TDECQ - optimizing time center of eye

IEEE P802.3bs Interim Meeting, Charlotte, NC, September 2017

Illustration of the problem

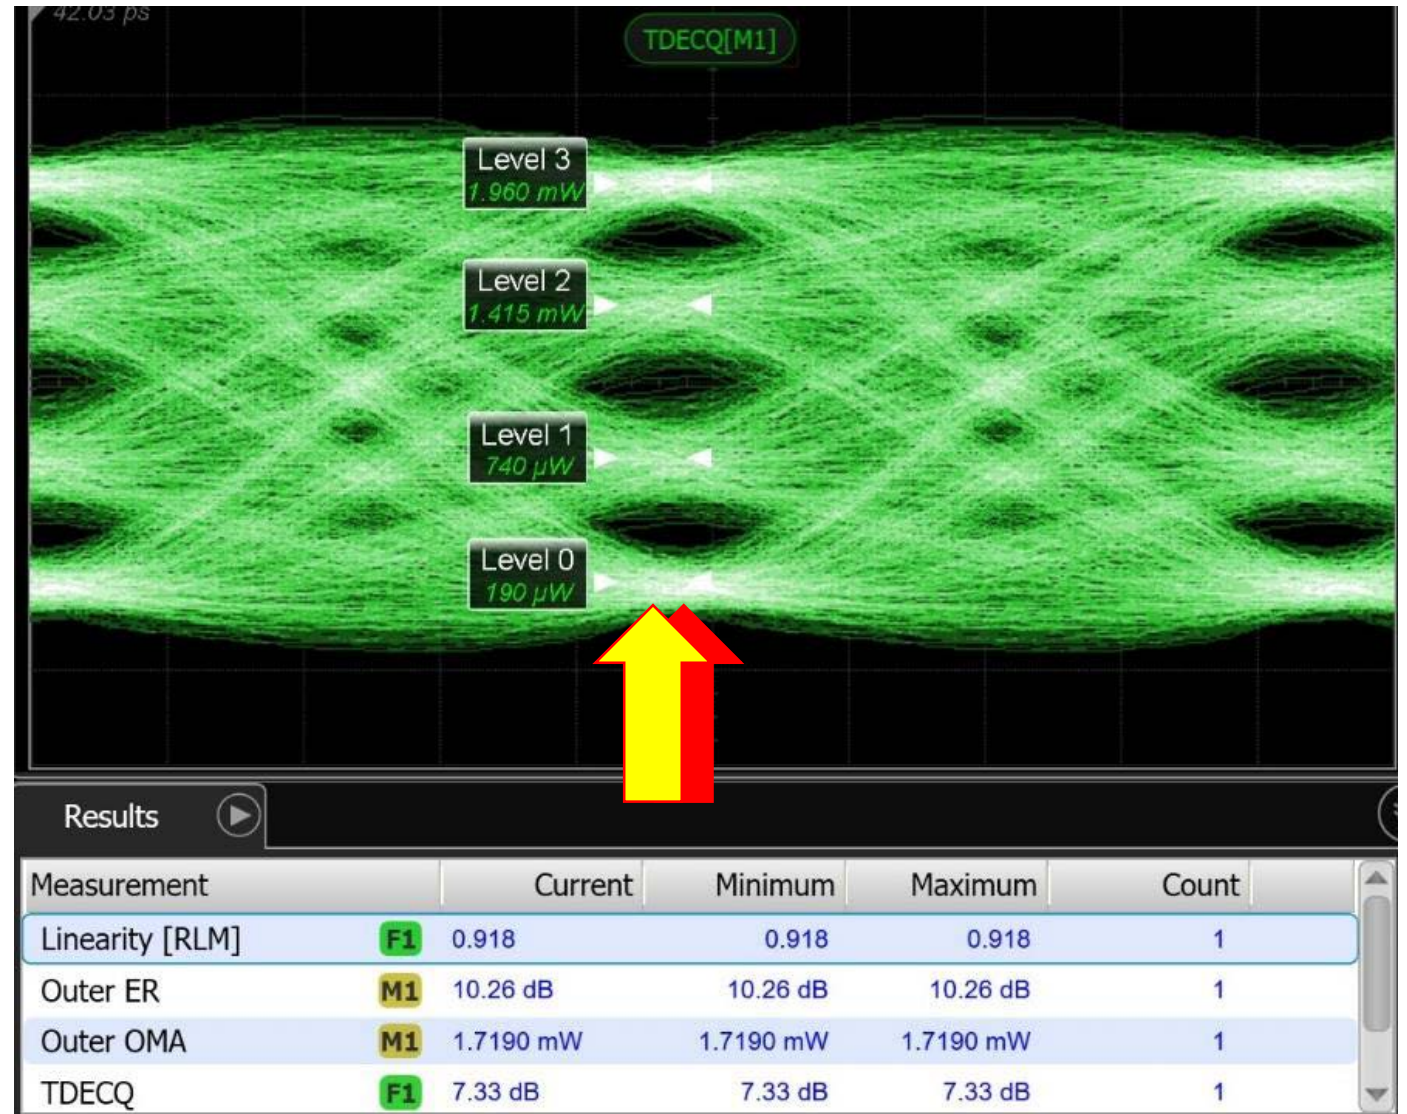
- The **yellow** arrow shows where the time-centre of the eye is calculated to be, based on the current definition in D3.3
- Allowing the left and right histograms to shift to the right (to the **red** arrow) would reduce TDECQ, and would reflect the capabilities of T spaced and T/2 spaced equalizer implementations..

The suggested remedy allows the pair of histograms to be adjusted left or right of their respective 0.45 and 0.55 UI positions, but still requires them to be spaced by 0.1 UI

Figure 121-5—Illustration of the TDECQ measurement

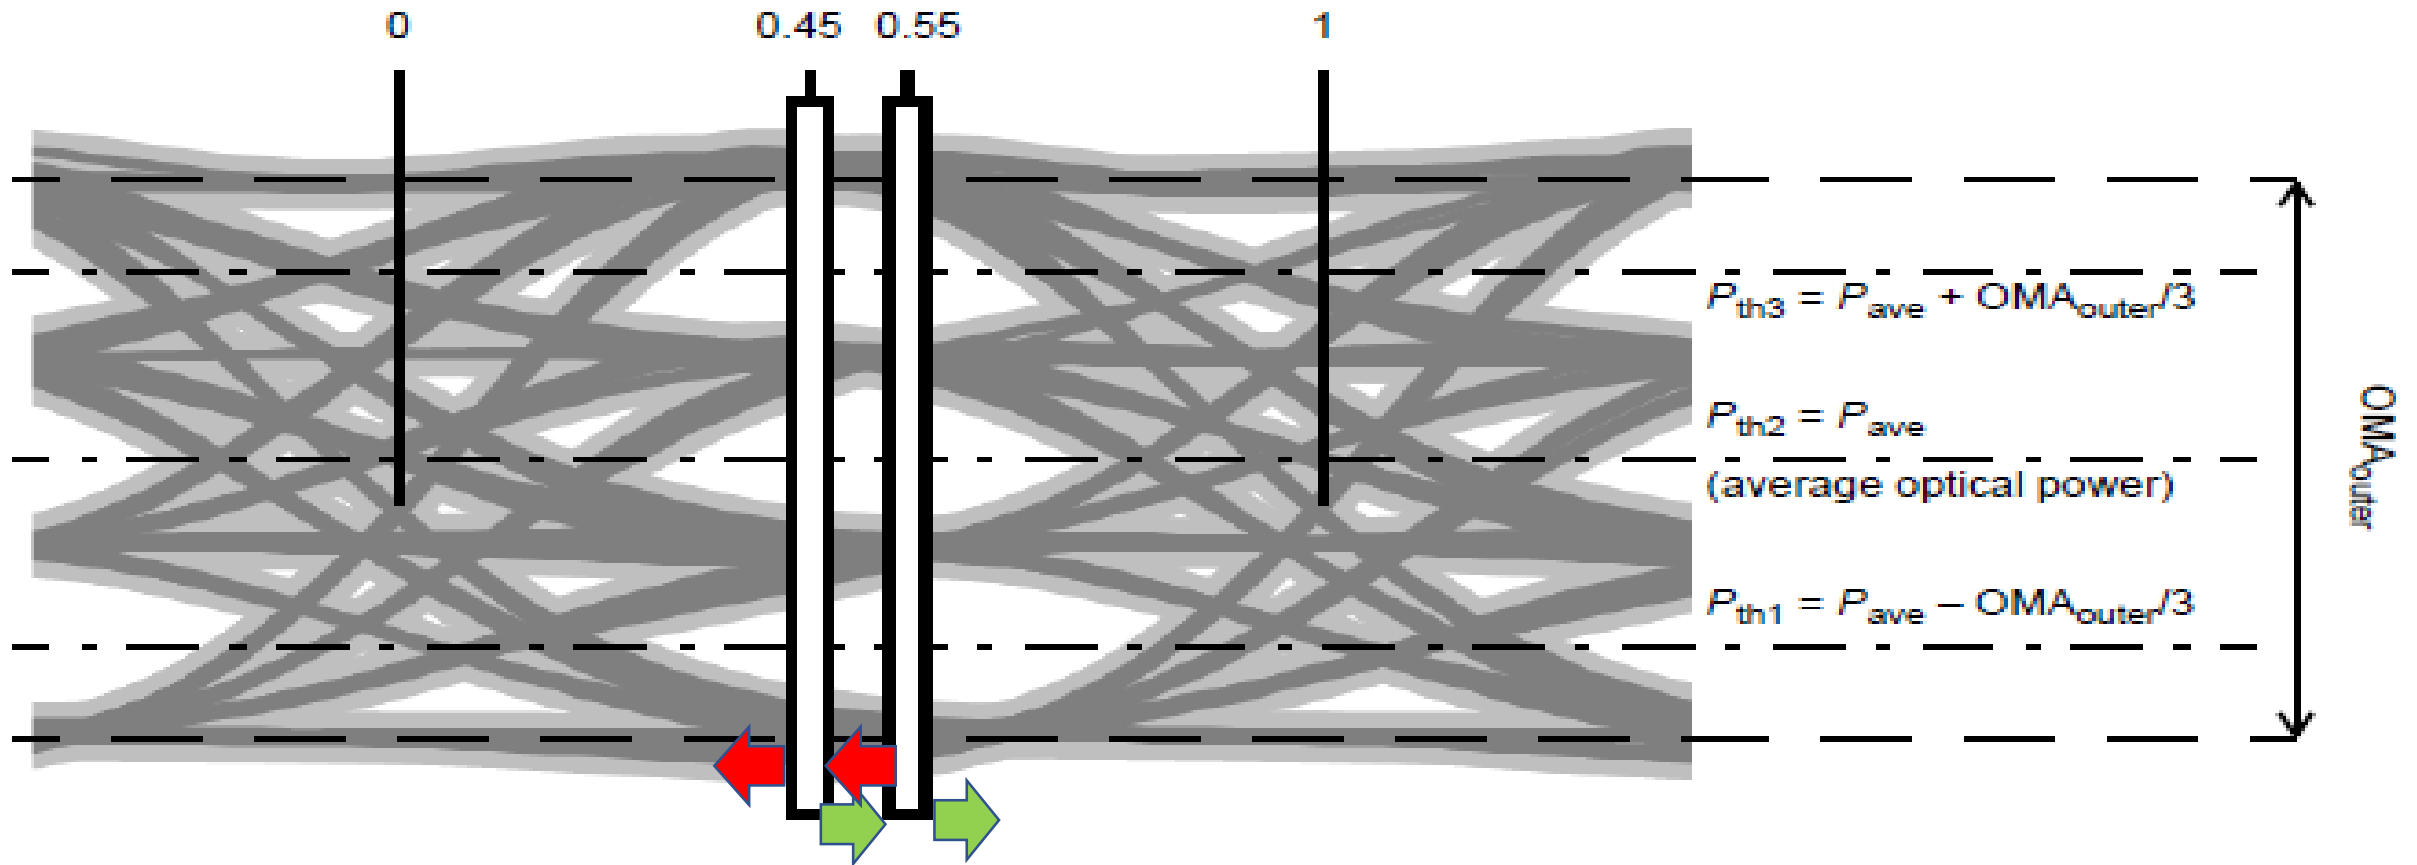
Two vertical histograms are measured through the eye diagram, centered at 0.45 UI and 0.55 UI. Each of the histogram windows spans all of the modulation levels of the eye diagram, as illustrated in Figure 121-5.

- In 121.8.5.3, replace the paragraph “Two vertical histograms are measured through the eye diagram, centered at 0.45 UI and 0.55 UI. Each of the histogram windows spans all of the modulation levels of the eye diagram, as illustrated in Figure 121–5. ” with “Two vertical histograms are measured through the eye diagram, **nominally** centered at 0.45 UI and 0.55 UI. Each of the histogram windows spans all of the modulation levels of the eye diagram, as illustrated in Figure 121–5. **The precise time position of the 0.45 UI and 0.55 UI histograms may be adjusted (e.g. to minimize TDECQ), but the histograms must be spaced 0.1 UI apart.**”
